WATER PERMIT NO. 7921-3

Name of Applicant: Owen & Lamont Peterson

**REVISED RECOMMENDATION OF CHIEF ENGINEER FOR WATER
PERMIT APPLICATION NO. 7921-3, Owen and Lamont Peterson**

Figure 2: Geologic Cross Section of the area of interest in the Prairie Coteau aquifer, as submitted by Summit Envirosolutions, Inc. (2014).

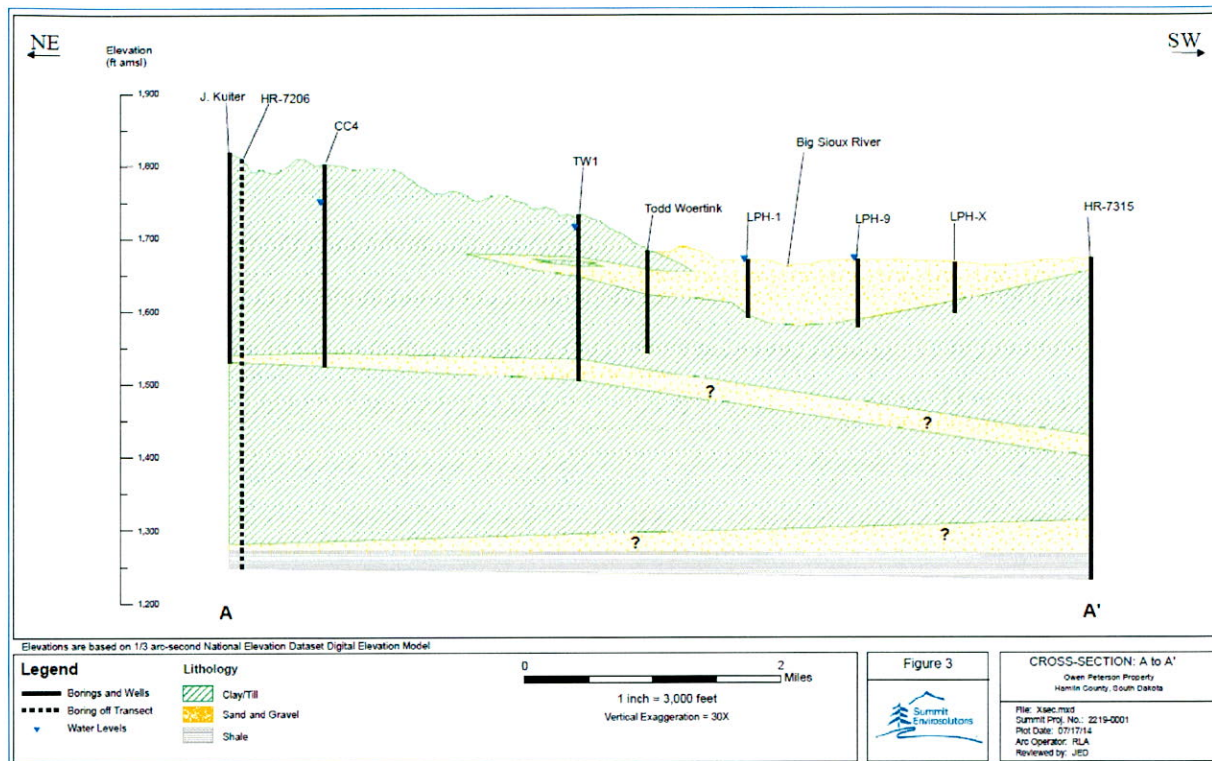
Given a series of wells that Summit Envirosolutions, Inc. contends are completed into the same portion of the Prairie Coteau aquifer (see Figure 2), a seven day aquifer pump test was conducted at a continuous flow rate of 730 gallons per minute (gpm) with measurement of water levels in these wells. The wells used for drawdown observations were located 100, 6,025, and 10,480 feet from the proposed production well and are referred to in the text as TW1, JC1, and CC4, respectively. Figure 2 displays the cross section whose aerial view is displayed in Figure 1 as a red line. The well designated JC1 falls outside of the cross section and is therefore not displayed in Figure 2. The production well used for pumping is referred to as PW1 and is within 100 feet of TW1. Given the measured drawdown and recovery in each of these, Summit calculated the radius of the cone of depression or radius of influence to be approximately 11.4 miles. The aquifer pump test report that was submitted to the Water Rights Program, and the data included in it, support this value.

Figure 3: Drawdown curve and trend line chosen by Summit for PW1 (Summit, 2014).

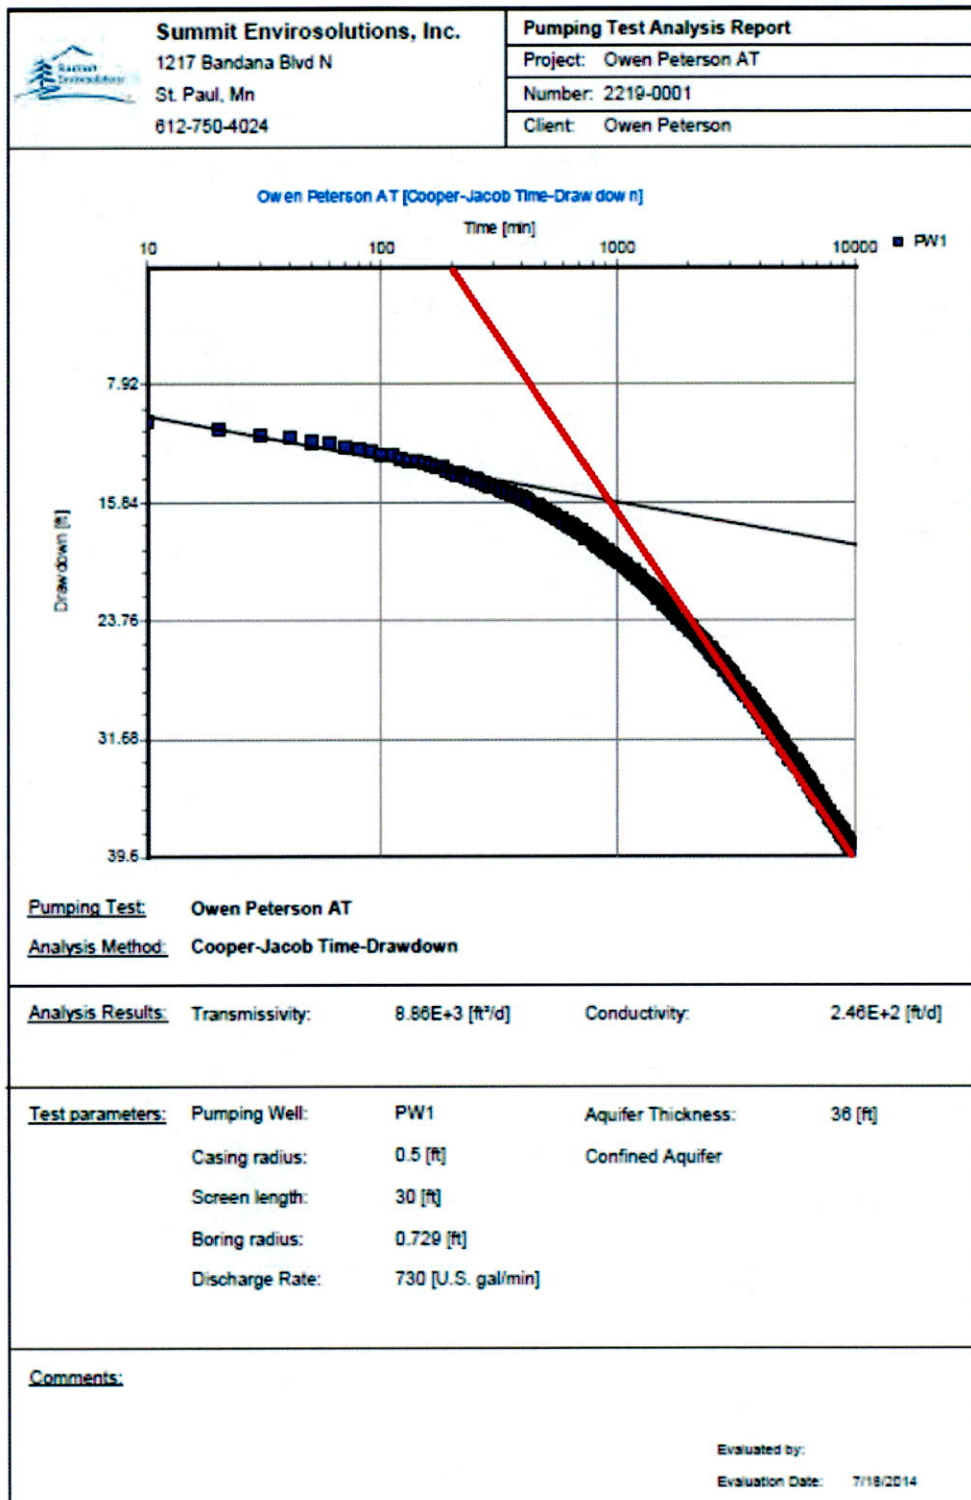
Values for the transmissivity, conductivity, and storativity were calculated in the report for the initial drawdown and the subsequent recovery using the Cooper-Jacob Drawdown and Theis Recovery methods. The values of these parameters are in general agreement in the two times that they were calculated for each method. Average transmissivity in the tests was found to be approximately $8,892 \frac{ft^2}{day}$, with hydraulic conductivity averaging 244 ft/day and storativity at 0.0014, respectively. The storativity was only calculated once using the Cooper Jacob Drawdown Method and is not an average. In calculating the values using the Cooper Jacob

Drawdown Method, Summit Envirosolutions, Inc. used the slope created in the first 200 minutes of drawdown data, commonly known as “early time data” (shown as a black trend line on Figure 3). Using the slope of the last of the drawdown data known as the “late time data” (shown as a red trend line on Figure 3) the calculated transmissivity drops to approximately $1,032 \frac{ft^2}{day}$, or less than one eighth of the originally calculated value. Early time data is typically considered to be less reliable than late time data due to the influence of water stored within the well bore. Early time data is generally reflective of the conditions within the well bore and the water being pumped directly from it. Late time data represents the conditions within the water bearing formation itself as at that point water is flowing directly from the aquifer in order to supply the desired flow rate (Walton, 1990).

Using the slope of the late time data, the hydraulic conductivity also drops by an order of magnitude to approximately 29 ft/day. Smaller values will result in a greater drawdown and a decreased radius of influence. However, given the level of head above the aquifer, it is unlikely that these changes will increase drawdown enough to cause impairment of other wells completed into the formation. See the Existing Water Rights section below.

Figure 4: Distance versus Total Drawdown Between Wells TW1 and CC4 (Summit, 2014).

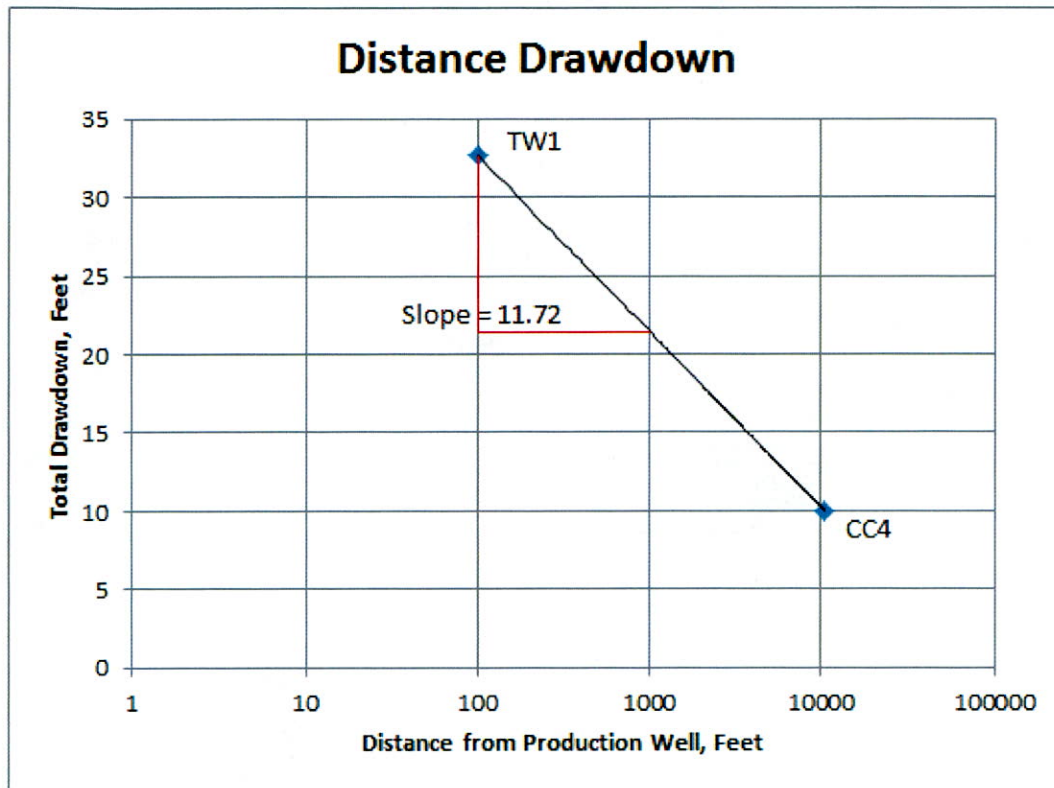
From the observed drawdown at CC4, the radius of influence was estimated to be approximately 11.4 miles from PW1, at least in the direction of CC4. Using the Cooper-Jacob distance drawdown analysis of the data (see Figure 4), transmissivity and storativity were calculated to be $4,397 \frac{ft^2}{day}$ and $1.92E-5$, respectively. The storativity value is approximately two orders of magnitude smaller than that calculated by Summit Envirosolutions, Inc.

ΔS = Slope of drawdown per one log unit of distance, base 10 (see Figure 4)

Figure 5: Drawdown and recharge curves for the water levels in the four wells observed (Summit, 2014).

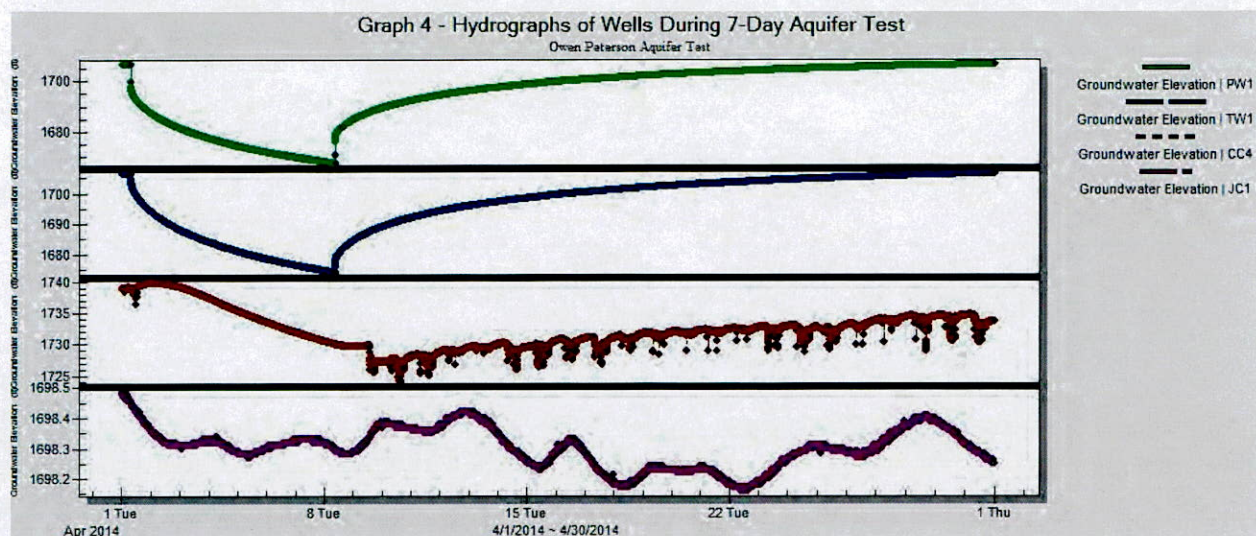
As shown in Figure 5, the lack of inflections in the drawdown curve during the pump test can be interpreted to mean no aquifer boundaries were encountered within the radius of influence during the test, as least in the direction of CC4. Combined with a full recovery of water levels in the production well (PW1) and adjacent test well (TW1) within three weeks of the end of the aquifer pump test, the lack of inflections in the drawdown curve can be used to conclude that this well is capable of producing the flow rate required for this project.

The other measured well completed into the formation, CC4, did not show a full recovery within the observed time period subsequent to pumping. However, CC4 did show increasing water levels over that time and it is very likely that full recovery was hampered by pumping from that well. Pump test data suggests JC1 is not affected by pumping from PW1 and instead responds primarily to local precipitation events and changes in atmospheric pressure.
